Access Compliance Report

Public Rights-of-Way

(Curb Ramps)

Intersection ID: 2698	Main Street: GRABURN'S_FORD_DR	Cross Street: HIGHLAND_CREEK_PY	Location: NW
ADA ID: 6432002E6156	Ramp Type: Perp	Initial Pass/Fail: Fail	Overall Compliance: No
Severity Score: 22.5			
Codes/Mitigation Info/Possible Solution		Field Measurements/Component Compliance

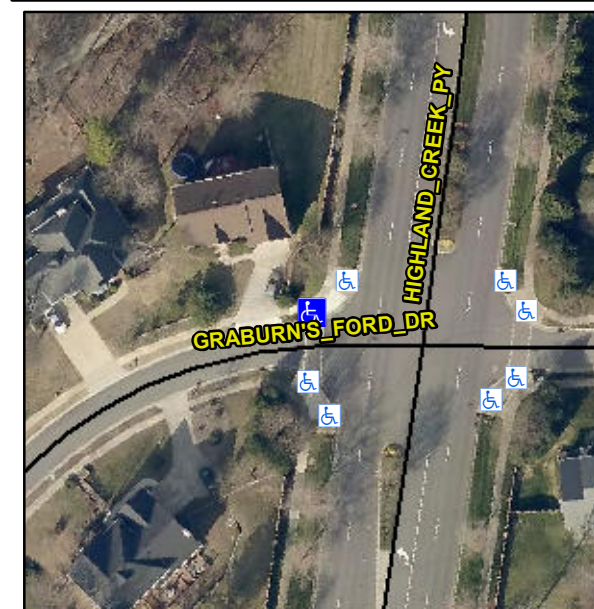
R304.5.1, R304.2.2, R304.5.3

Compliance	Description	Data	Compliance	Description	Data
N/A	Ramp Length (in)	68.5	No	Ramp Slope (%)	10.0
No	Ramp Width (in)	37.0	No	Ramp XSlope (%)	3.5
N/A	Flare Type LT	N/A	N/A	Flare Type RT	N/A
N/A	Flare Slope LT (%)	N/A	N/A	Flare Slope RT (%)	N/A
N/A	Flare Traversable LT?	N/A	N/A	Flare Traversable RT?	N/A
N/A	Landing Length (in)	N/A	N/A	DWS Provided?	N/A
N/A	Landing Width (in)	N/A	N/A	DWS Contrast?	N/A
N/A	Landing Slope (%)	N/A	N/A	DWS Length (in)	N/A
N/A	Landing X Slope (%)	N/A	N/A	DWS Full Width?	N/A
N/A	Landing Curb? (Y/N)	N/A	N/A	DWS Offset (in)	N/A
N/A	Shared Landing?	N/A			
N/A	Gutter Ponding?	N/A	N/A	Gutter Slope (%)	N/A
N/A	Gutter Lip Ht (in)	N/A	N/A	Gutter X Slope (%)	N/A
N/A	Painted X Walk1?	Yes	N/A	Painted X Walk2?	N/A
	X Walk 1 Direction	To S		X Walk 2 Direction	N/A
N/A	X Walk 1 Width (in)	95.0	N/A	X Walk 2 Width (in)	N/A
	X Walk 1 Slope (%)	4.5		X Walk 2 Slope (%)	N/A
	X Walk 1 X Slope (%)	5.6		X Walk 2 X Slope (%)	N/A

Remove & Replace Entire Ramp.
